# UNITED STATES PATENT AND TRADEMARK OFFICE

APPLICATION NO.	FILING DATE	FIRST NAMED INVENTOR	ATTORNEY DOCKET NO.	CONFIRMATION NO.
10/670,159	09/23/2003	Fernando R. Moncho	12158/5	2830
757	7590	04/06/2006	EXAMINER	
BRINKS HOFER GILSON & LIONE P.O. BOX 10395 CHICAGO, IL 60610			HORTON, YVONNE MICHELE	
			ART UNIT	PAPER NUMBER
			3635

<b>Office Action Summary</b>	<b>Application No.</b>	<b>Applicant(s)</b>	
	10/670,159	MONCHO ET AL.	
	<b>Examiner</b>	<b>Art Unit</b>	
	Yvonne M. Horton	3635

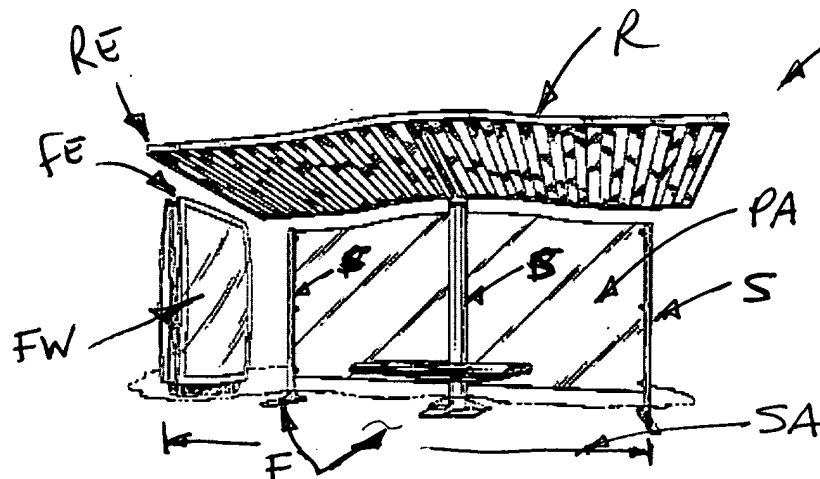
Claims 16-19,25 and 26 are rejected under 35 U.S.C. 102(b) as being anticipated by Design Patent #438,635 to Da COSTA. Da COSTA discloses a shelter (S) including a plurality of upstanding supports (S) from a fixed foundation (F) and arranged to partially surround a spatial area (SA); a roof (R) having a first edge (RE) and mounted to the supports (S) such that the roof (R) is positioned over the spatial area (SA); and at least one freestanding wall structure (FW) substantially unconnected to the roof (R) and

wall (W); wherein, the freestanding wall structure (FW) has a first edge (FE) that is parallel to the a first edge (RE) of the roof (R). Regarding claim 17, it is inherent that if the freestanding wall (FW) is not connected to the wall structure (W), roof (R), or supports (S) no vibration will be transferred except through the foundation (F) because everything is connected to the foundation (F) and not to one another. In reference to claim 18, the at least one wall structure (W) is secured to the at least one supports (S) and extends partially between the roof (R) and the foundation (F). In reference to claim 19, the wall (W) also extends between at least two supports (S). Regarding claim 25, the freestanding wall structure (W) is perpendicular to the at least one wall (W). In reference to claim 26, the freestanding wall (FW) extends partially beneath the roof (R).

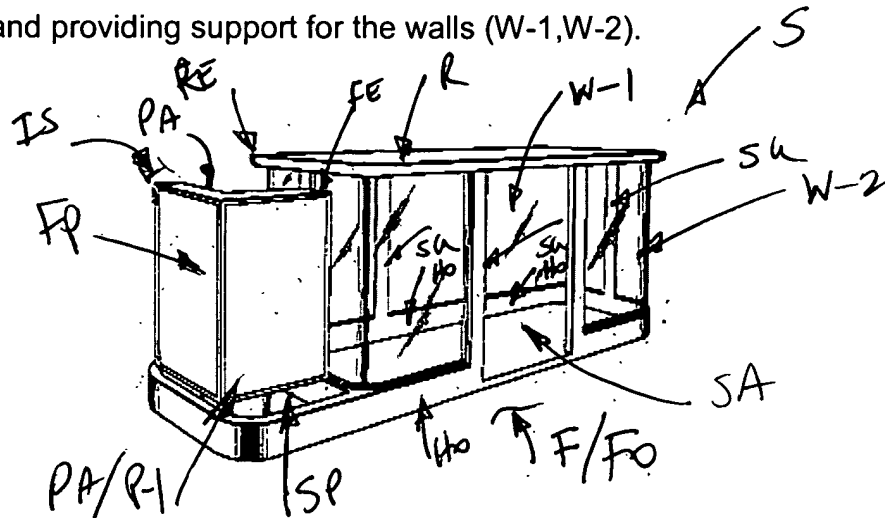
Claims 16,18 and 24 are rejected under 35 U.S.C. 102(b) as being anticipated by Design Patent #250,836 to LAHAIE. LAHAIE discloses a shelter (S) including a plurality of upstanding supports (SU) from a fixed foundation (F) and arranged to partially surround a spatial area (SA); a roof (R) having a first edge (RE) and mounted to the supports (SU) such that the roof (R) is positioned over the spatial area (SA); and at least one freestanding wall structure (FP) substantially unconnected to the roof (R) and

wall (W-1,W-2); wherein, the freestanding wall structure (FP) has a first edge (FE) that is parallel to the a first edge (RE) of the roof (R). In reference to claim 18, the at least one wall structure (W-1,W-2) is secured to the at least one supports (SU) and extends partially between the roof (R) and the foundation (F). Regarding claim 24, the shelter (S) further includes a plurality of horizontal members (HO) extending between at least two supports (SU) and providing support for the walls (W-1,W-2).

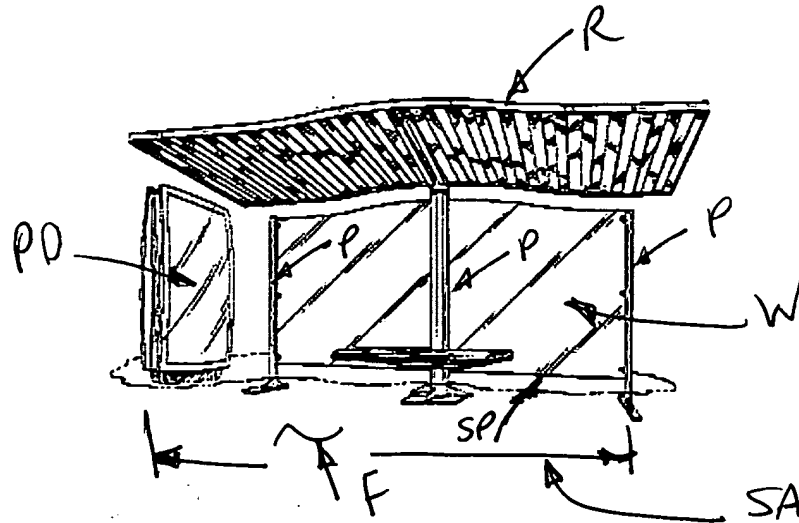
Claims 28 and 29 are rejected under 35 U.S.C. 102(b) as being anticipated by Design Patent #438,635 to Da COSTA. Da COSTA discloses the method of providing a shelter including the steps of providing a plurality of upstanding supports (P) secured to a foundation (F) and partially surrounding a spatial area (SA); providing a roof (R) secured to the plurality of supports (P); providing at least one wall (W) secured to at least one support (P) wherein the wall (W) provides a space (SP) between the foundation (F); and providing at least one freestanding wall structure (PD) such that there is a space (SP), between the freestanding wall (PD) and the structure. Regarding claim 29, it is inherent that due to the fact that there are no physical connections between the freestanding wall (PD) and the roof (R), supports (P), or walls (W) of the

shelter, other than the foundation (F), that the freestanding wall (PD) is allowed to vibrate in "isolation" from the supports (P), roof (R), and wall (W).

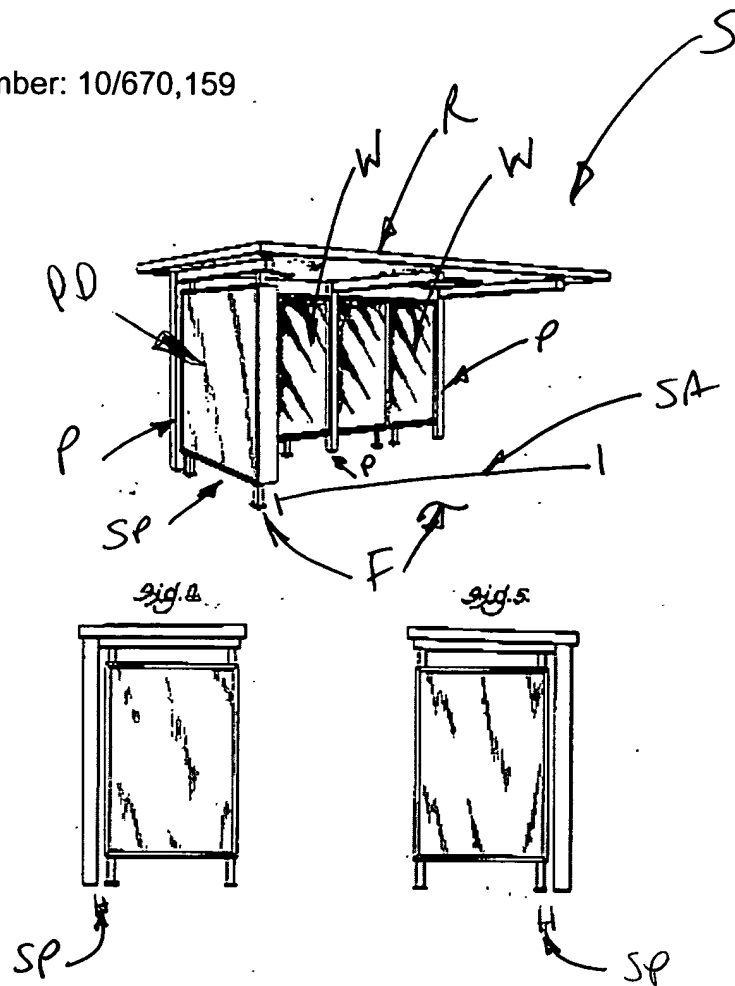
Claim 28 is rejected under 35 U.S.C. 102(b) as being anticipated by Design Patent #252,215 to LEUTHESSER. LEUTHESSER discloses the method of providing a shelter including the steps of providing a plurality of upstanding supports (P) secured to a foundation (F) and partially surrounding a spatial area (SA); providing a roof (R) secured to the plurality of supports (P); providing at least one wall (W) secured to at least one support (P) wherein the wall (W) provides a space (SP) between the foundation (F); and providing at least one freestanding wall structure (PD) such that there is a space (SP), see figures 4 and 5, between the freestanding wall (PD) and the structure.
